FORT LAUDERDALE AIRPORT TRAFFIC CONTROL TOWER
MAJOR IMPROVEMENTS
ARCHITECTURAL
CAB LEVEL FLOOR AND ROOF PLANS

DESIGNED	GMR	ISSUED BY	DATE	JCN
DRAWN	GMR	ATLANTA TERMINAL ENGINEERING CENTER	JAN 31, 2020	1508912
CHECKED	NKE		DRAWING NO	
				FLL-D-ATCT- A103

1 CAB FLOOR PLAN
A103 SCALE: 1/4" = 1' - 0"

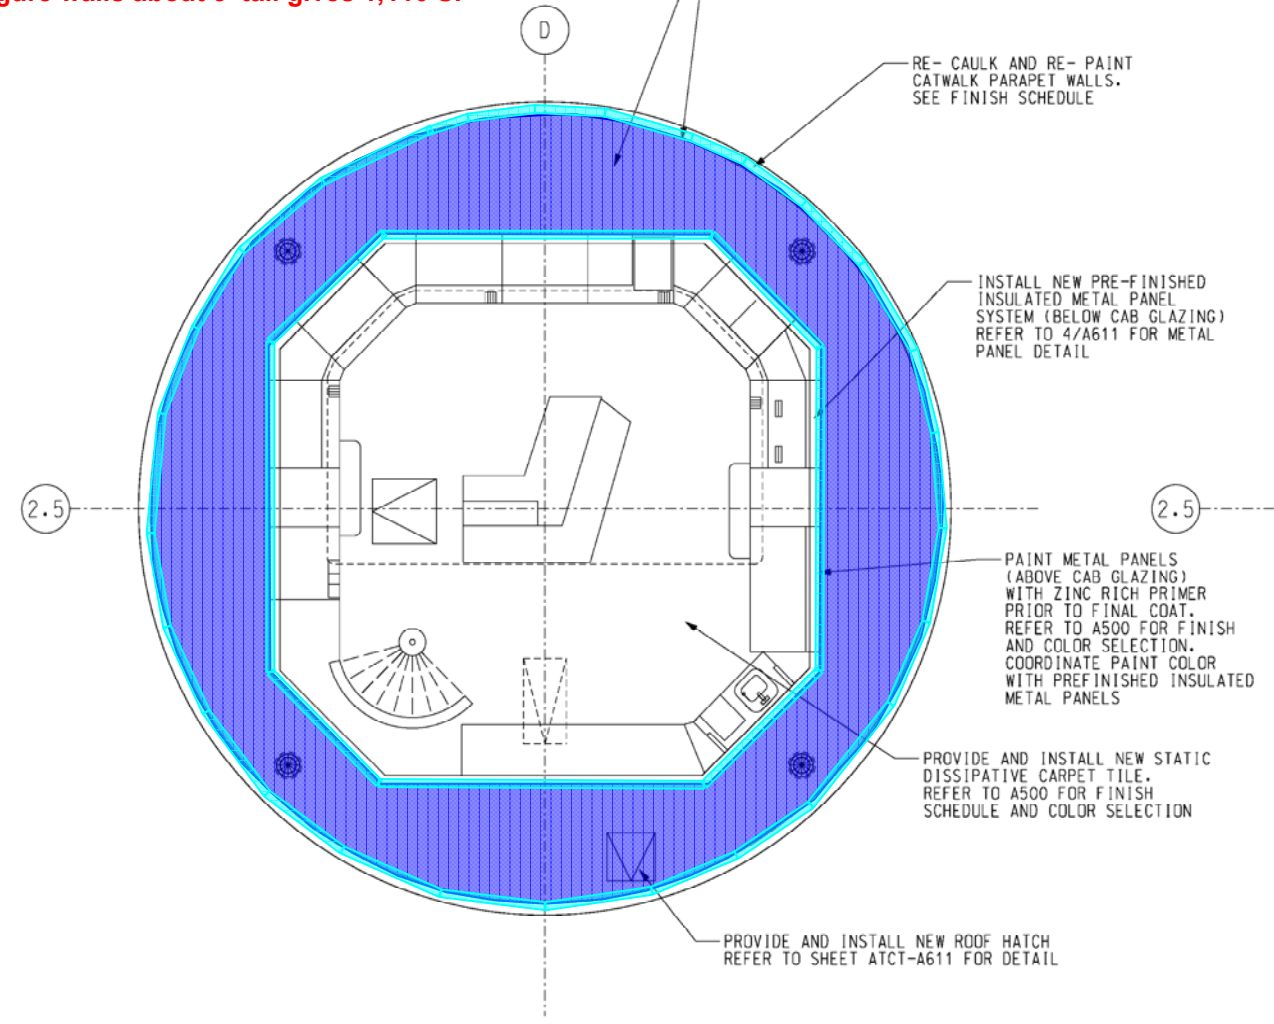
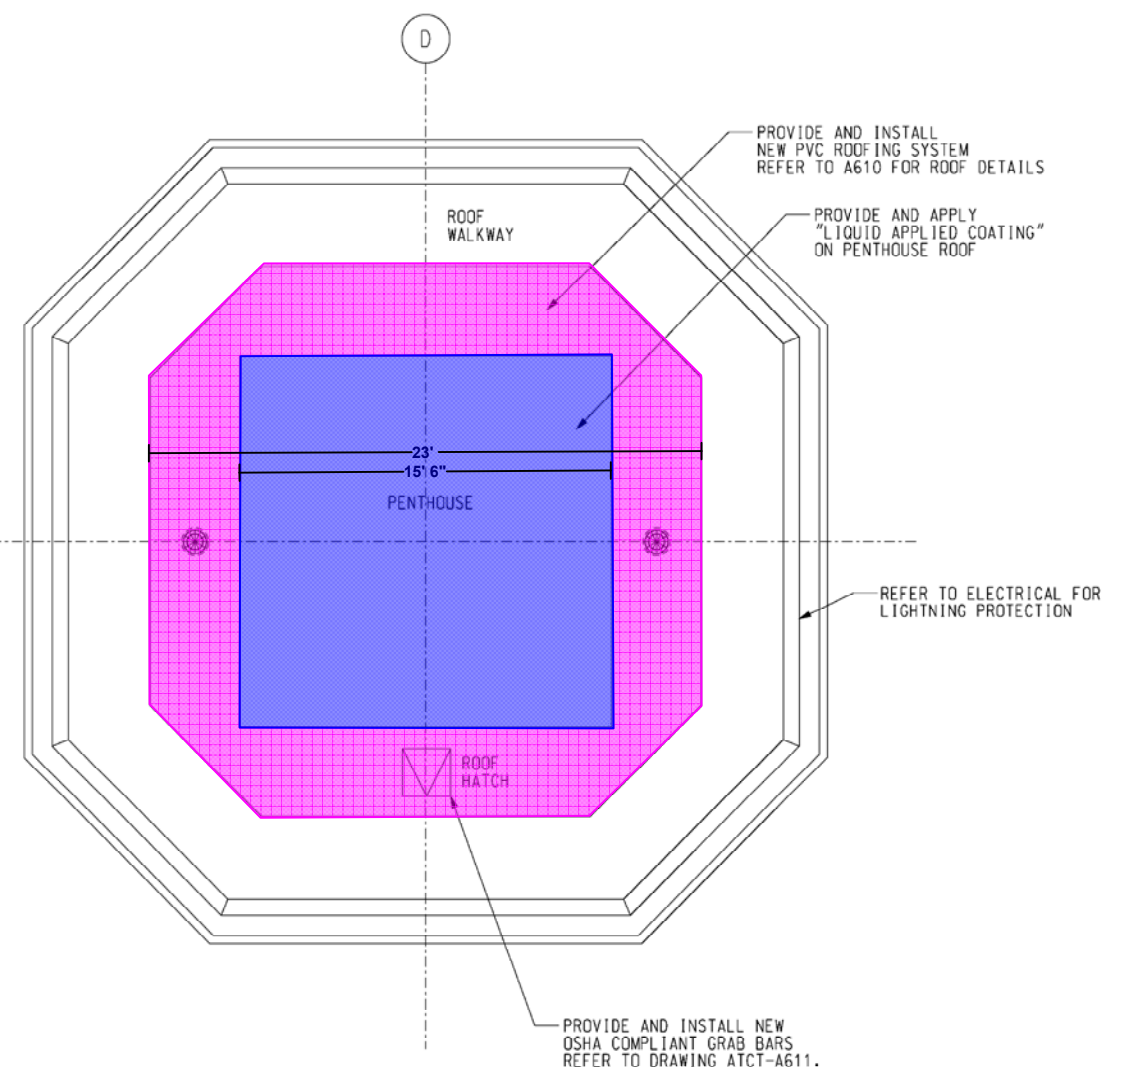
- 1 - 07500 Roofing PVC - 246 SF
- 2 - 00000 Scale Check - 8 LF
- 3 - 07500 Roofing Fluid Applied Roof - 609 SF
- 4 - 07500 Catwalk Walls - 185 LF

Figure walls about 3' tall gives 1,110 SF
